**ADDENDUM NO. 1
MARANACOOK LAKE OUTLET DAM MODIFICATIONS
TOWNS OF READFIELD AND WINTHROP, MAINE**

Responses to Bidder Questions asked Verbally at Pre-Bid Conference

Responses to Bidder Questions submitted in Writing

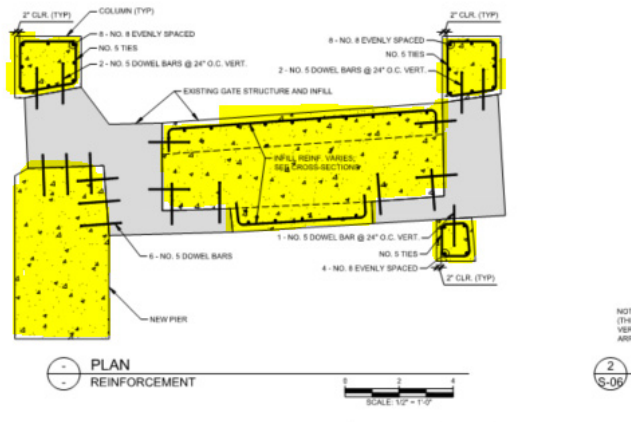
16. Question: Please note drawing S-04; Per both the typical and critical sections, and the plan view along the top of the bank adjacent to the neighboring residence, it is noted that a new brick paver path is required, extents by owner. Please provide the width and length of the path, as well as the size, color and pattern of the required pavers. Additionally, please advise as to which bid item shall be used to cover this scope of work.

Answer: The brick paver path, including paver base, filter fabric, and bedding stone above El. 218, will be the responsibility of the abutting landowner and is not part of the Contractor's scope of work. The Contractor will install the rip-rap with bedding stone only up to El. 218. (Cutting back of the slope above El. 218 may be required incidental to placement of rip-rap and bedding stone.)

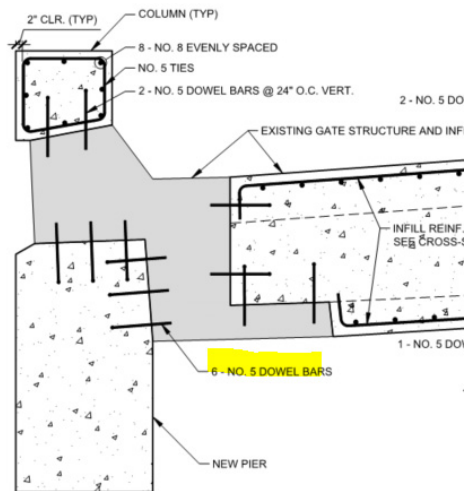
19. Question: Please confirm that the total quantity of #5 concrete dowels, for the new left abutment/pier to existing structure, is 6 as shown:

Answer: Confirmed. Quantity is six (6) dowels every 2 feet of height.
